DARLING SQUARE NW PLOT

DESIGN REPORT
FOR SECTION 96 APPLICATION (Mod 2)
TO MODIFY SSD 6013

October 2015

Figure 2.03 : Section 96 NW Plot ground plan design proposal

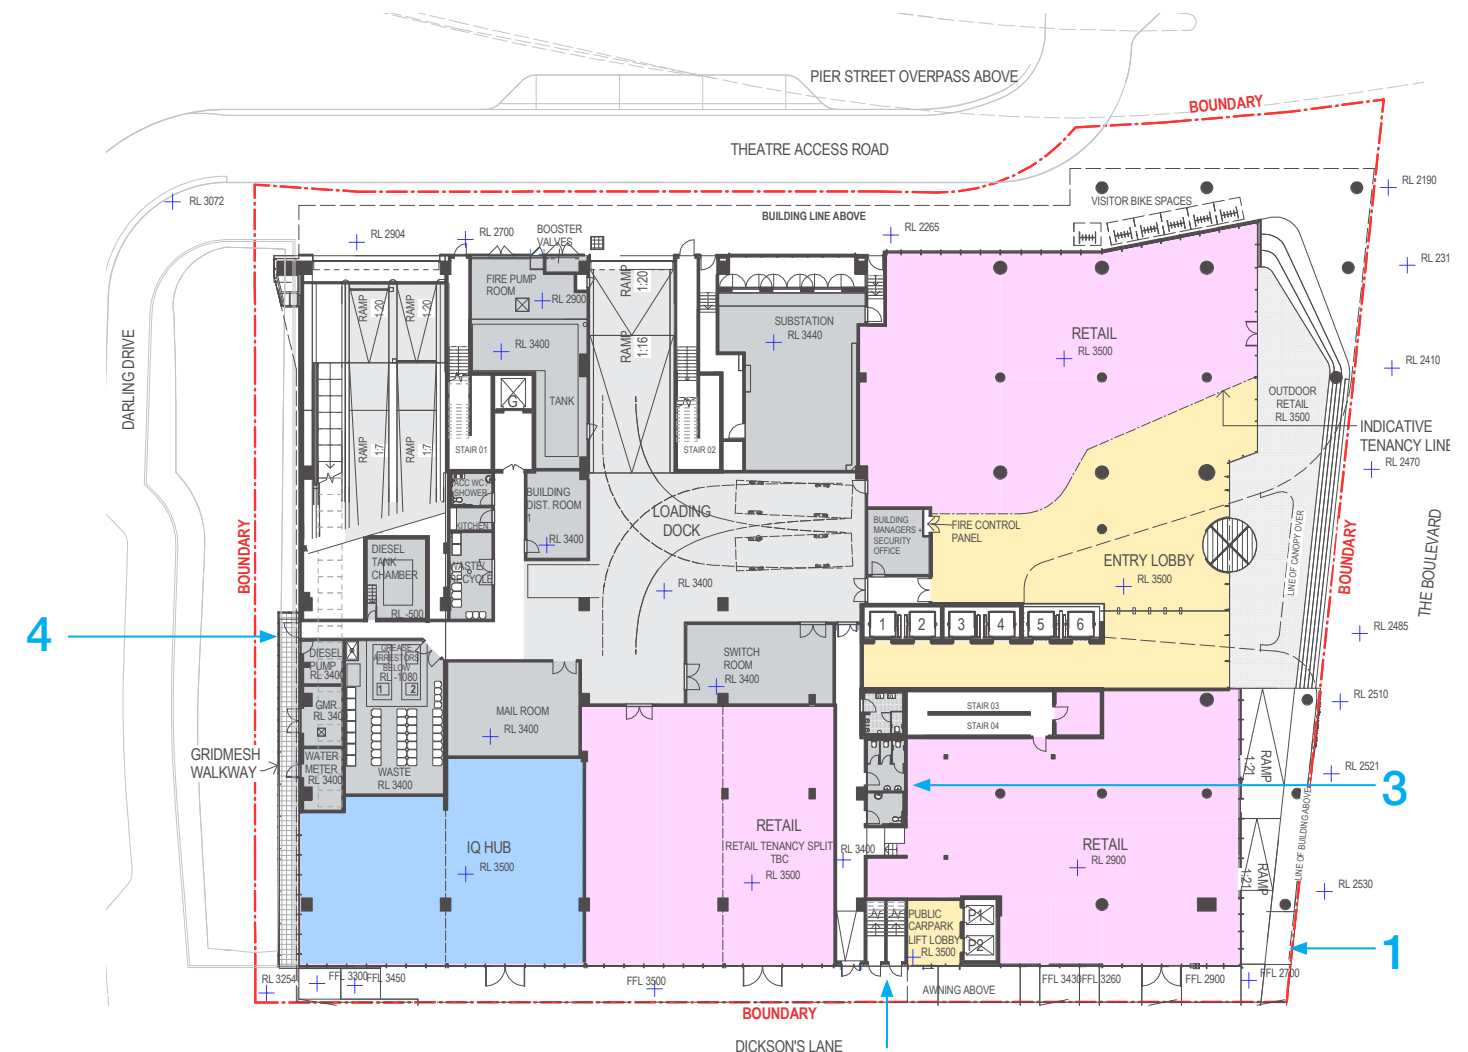
2.01 Amendments to Ground Floor

The design continues to deliver an active ground plane. The amendments include:

1. Revision of the structural design to the South East corner has provided greater visual and physical connections to the ground level tenancies from the Boulevard.
2. The fire escape from the southern building core has been suspended above the ground level tenancies to provide direct access for the tenancies to the loading dock.
3. Provision of shared amenities including dedicated male, female and unisex toilets for the proposed active ground floor uses accessed from Dickson's Lane.
4. Alternative fire escape to Western side of the building; cantilevered with no impact to bio-swale.

Figure 2.04 : Section 96 NW Plot proposed East elevation

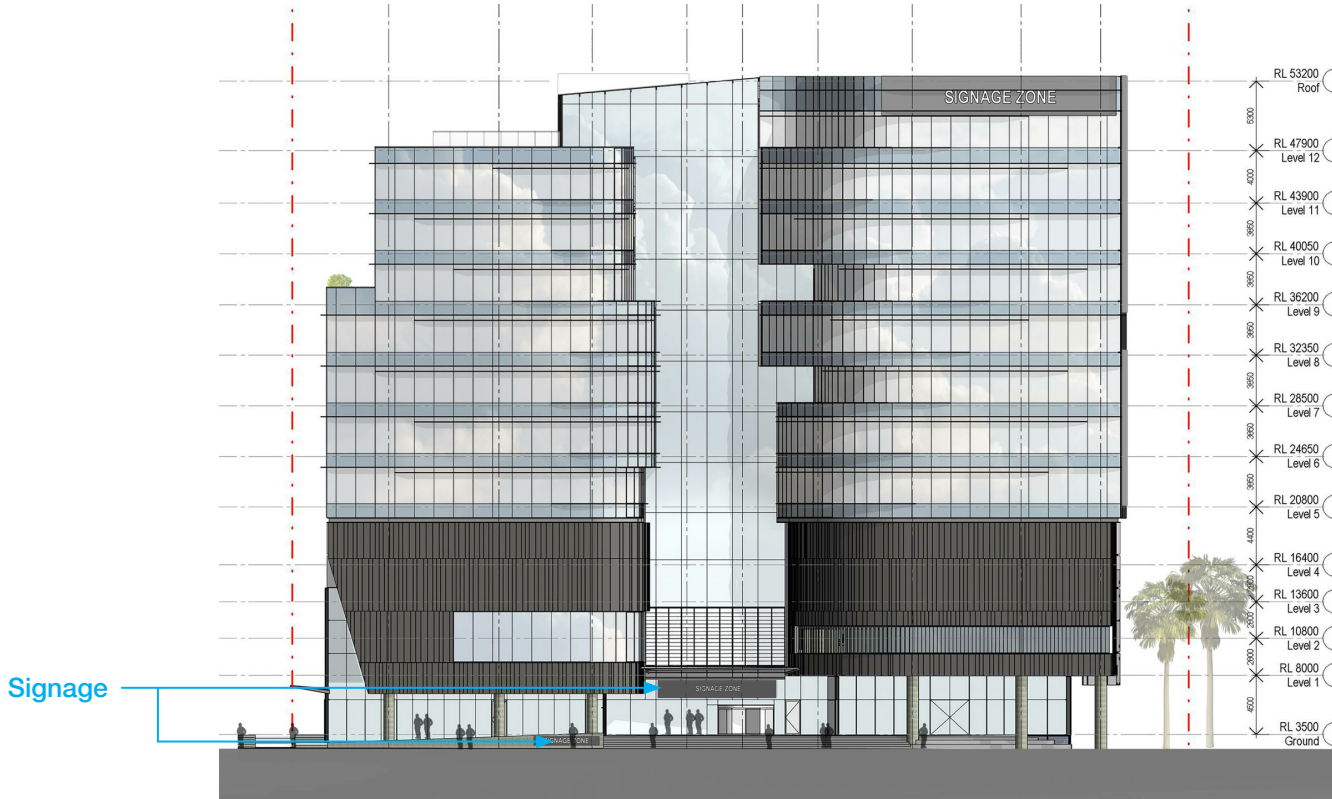
2.02 Awnings + Signage

To highlight the entry to the building and provide a sheltered access for the building users an awning has been introduced on the eastern facade. The sculptural shape complements the overall geometry of the building design.

A signage zone has been developed to identify the building and provide wayfinding for visitors below the eastern awning and a smaller ground level sign has been integrated into the exterior structure.

The signage zones located on the higher levels of the North, East and Western facades have been modified to accommodate the future tenant signage.

The fixed awning structure along Dickson’s Lane has been reduced to allow for bespoke retail designed awnings to enhance the laneway quality of this space.

Figure 2.08 : Section 96 NW Plot proposed East elevation

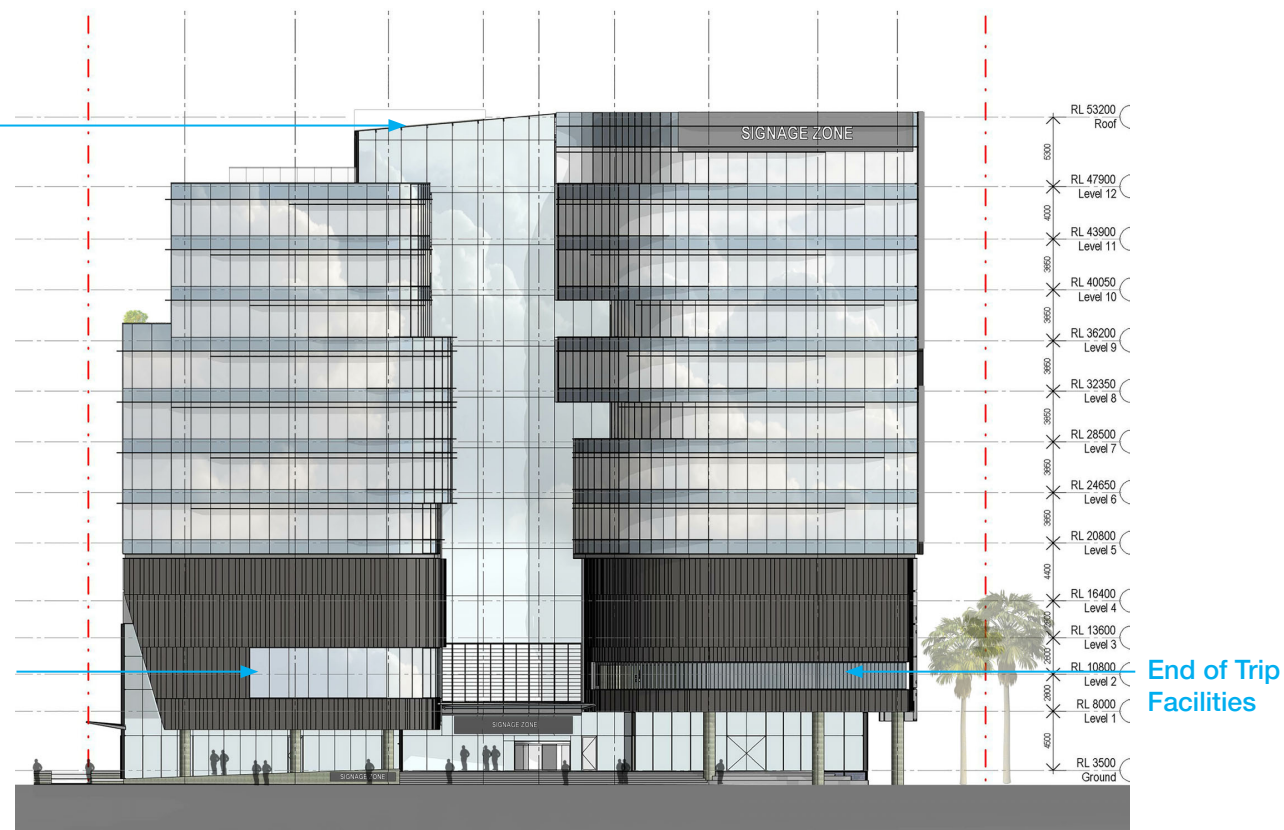
2.03 Facades

The glazed areas of the yoga/gym room to the south of the building entry and the end of trip facilities to the north of the building entry have been embedded in the surrounding metal cladding. The end of trip facilities storage area is to be a naturally ventilated space and permanently open louvred areas have been incorporated.

Design development to the atrium glazing resulted in a minor fall for water run off. To be able to wrap the eastern facade into the skylight a very minor slope is visible at the top of the east facade.

The facade around the carpark zones (Levels 1-4) has been enhanced to create finer architectural detail on all elevations, while maintaining the natural ventilation to the carpark, this includes:

- The eastern facade has been detailed with additional folds to soften the scale and bulk of the facade.
- The north, south and western facade panels have been refined in width to enhance the patina of the facade.

The south east corner of the building has been refined to create a feature architectural corner detail that will be animated signifying the entrance to Dickson's Lane from the Boulevard.

Through a revised reflectivity study, it was possible to reduce the number and depth of the vertical fins across the north facade. This significantly improves the outlook from the building of the office floors.

Figure 2.10 : Section 96 NW Plot proposed Level 12 Plan

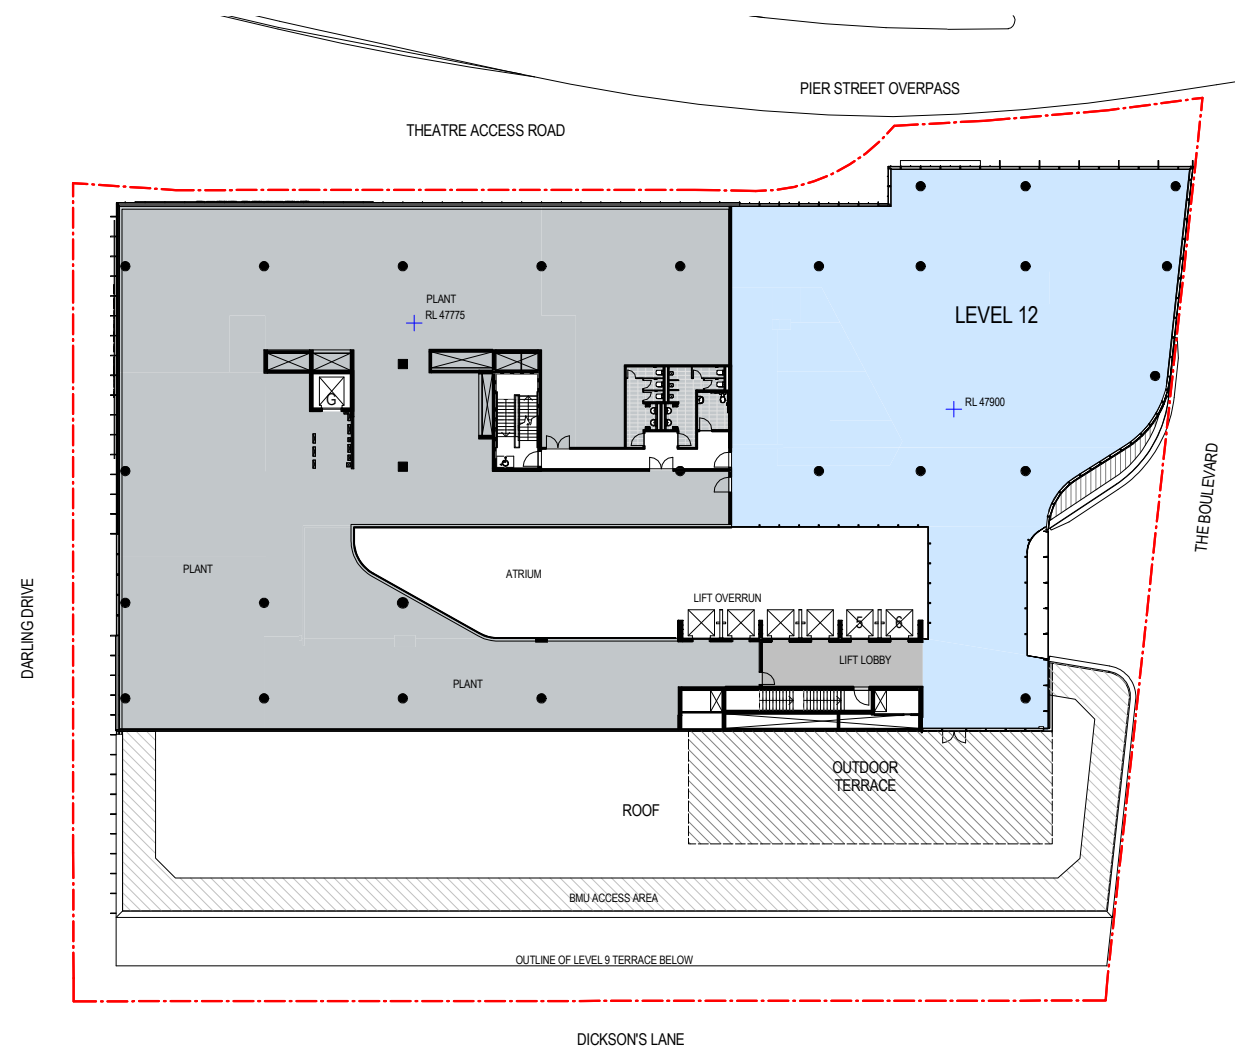
2.04 Change of Mechanical System and Roof Solar Panels

Changing the mechanical system from Low Temp VAV to chilled beams along with general design development efficiencies for other building services has enabled the plant areas to be significantly reduced. More usable floorspace is available on the typical floors and plant space is converted into office space on Level 12.

A small roof terrace is proposed to enable the future tenant with an alternative shared space. This will enhance the activation of the roof space and provide a unique opportunity for the building to connect with the adjoining developments.

Figure 2.11 : Section 96 NW Plot proposed Roof Plan with Solar Panels

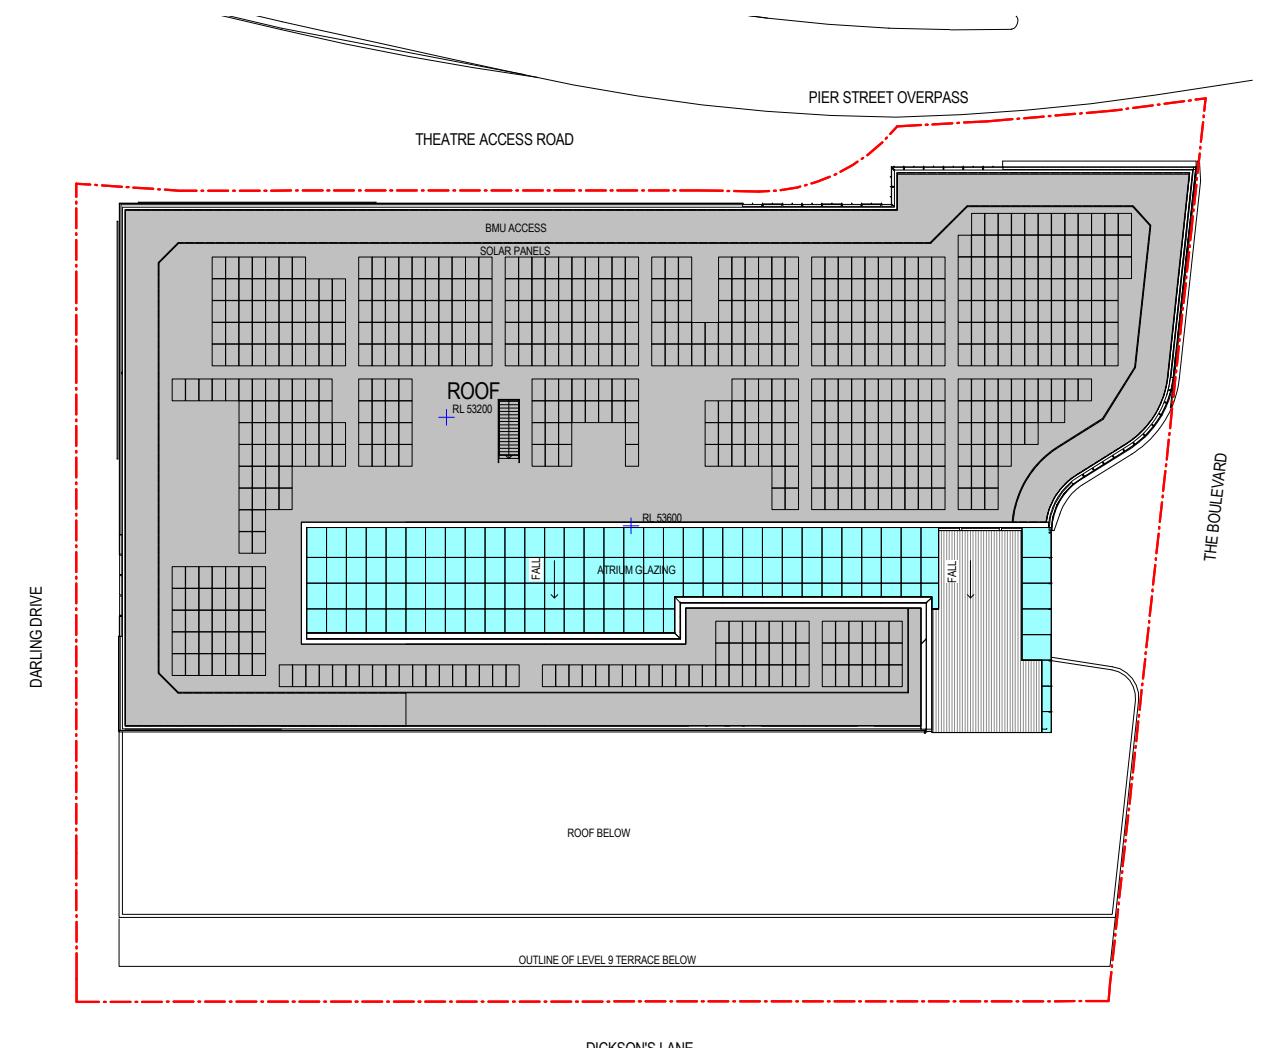
As part of the building sustainability and green star strategy solar panels on the roof have been incorporated. The power generated by the solar panels will reduce operating demands in peak times by the building and improve the overall precinct energy performance rating.
